# Technical Bulletin

SUBJECT: CIRCUIT PROTECTION FOR ZENER DIODE, D-301

30 E-300

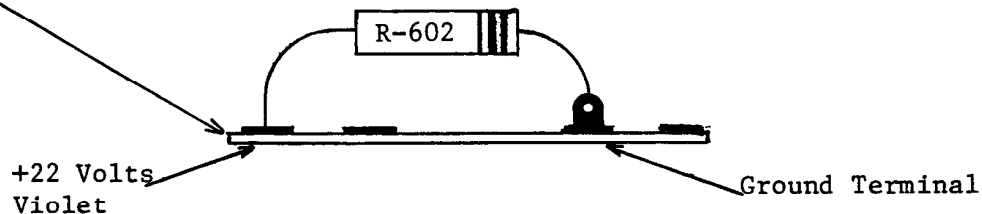
If you find it necessary to replace D-301; 22 Volt Supply Control Doide, we recommend adding resistor R-602; 1000 ohm, 2 watt, to the circuit as shown below. This diode is located in the Power Supply Section of the large chassis on the Console floor.

NOTE: Because the addition of this resistor is a simple matter, it is recommended you make this revision on all E-300 instruments you encounter.

Terminal strip just  
below Pedal Divider  
Board
